Subject: Response to Vapor Mitigation System Documentation and Additional Actions Needed
One Hour Martinizing, 1233 South Military Avenue, City of Green Bay, Wisconsin
BRRTS # 02-05-217270

Response to Vapor Mitigation System Documentation and Additional Actions Needed

SUB-SLAB VAPOR MITIGATION SYSTEM DIAGRAM

FIG-2

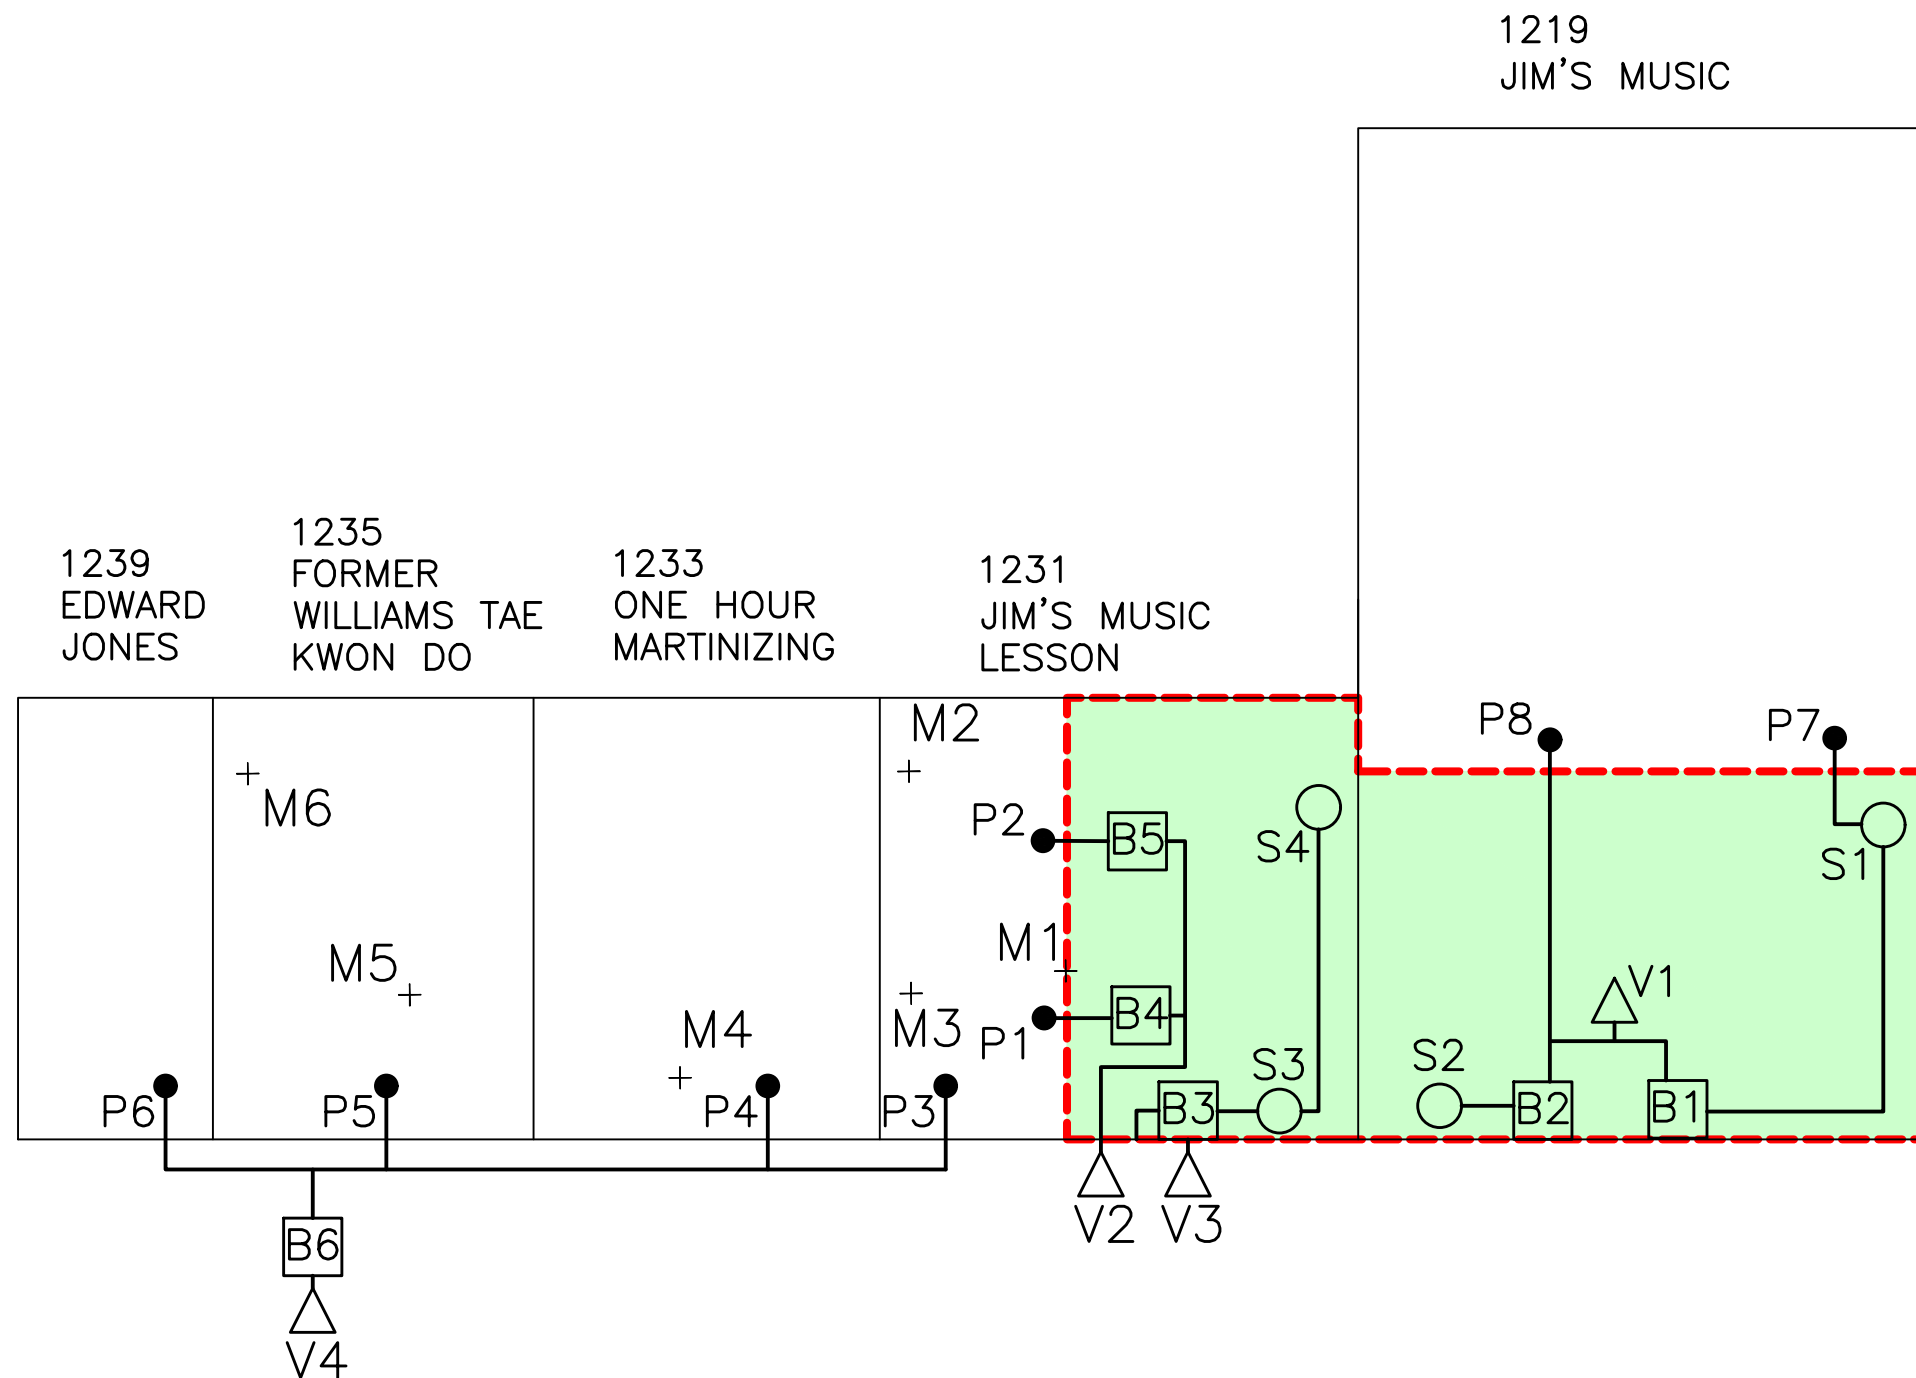
1. 1233 S Military Ave (One Hour Martinizing) has only one PFE point directly adjacent to the vapor extraction point. At a minimum, an additional PFE point should be added to the north side of One Hour Martinizing to ensure adequate vapor concentrations are being removed from the source area.

2. No PFE testing was performed at 1239 S Military Ave (Edward Jones). Although there were no sub-slab exceedances documented beneath this unit, PFE testing needs to identify the radius of influence of the system.

3. No PFE testing was performed at 1219 S Military Ave (Jim's Music). Although there were no sub-slab exceedances in this area, PFE testing needs to identify the radius of influence of the system. PFE testing needs to be performed in the basement as well.

Photo 13. Vacuum extraction blower B1, north basement.

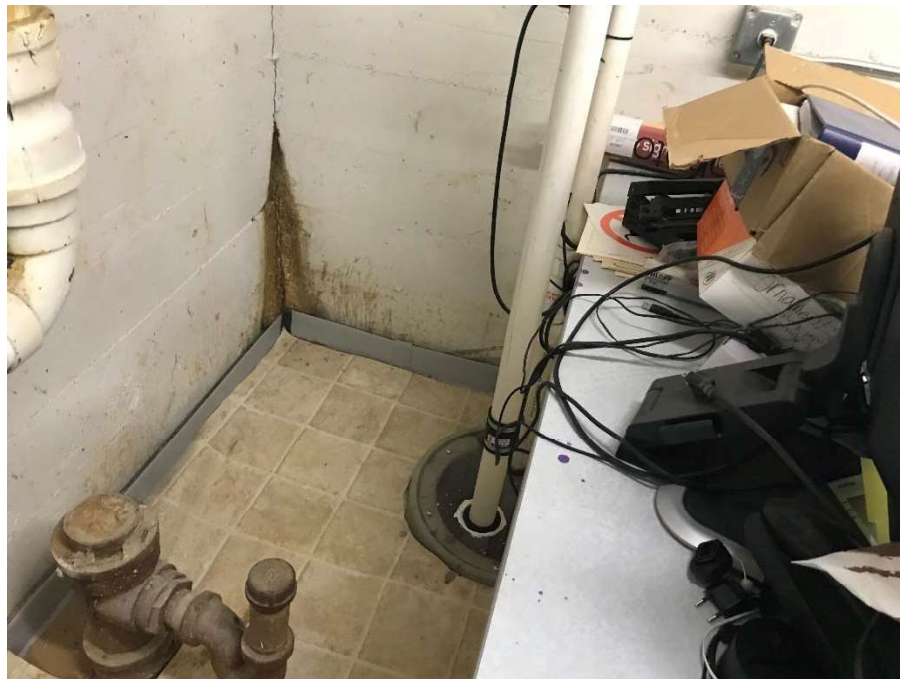
- a. Photos 7 and 13 in the June 2020 VMS Report show piping runs that will likely result in future moisture build-up as there is nowhere for rainwater or condensation to drain and will likely interfere with effectiveness of the VMS in the future.

- a. Photos 7, 9, 12, and 13 of the June 2020 VMS Report show that blowers B1, B2, B3, B4, and B5 are all within the basement (beneath/within conditioned space). These fans should be moved to the exterior or the building.

- a. Photos 7, 9, 12, and 13 of the June 2020 VMS Report show that blowers B1, B2, B3, B4, and B5 have no manometers to monitor system performance. There are vacuum readings listed in Table 1 of the report, however there are no photos of manometer readings. In addition to no manometer, there is no labeling.
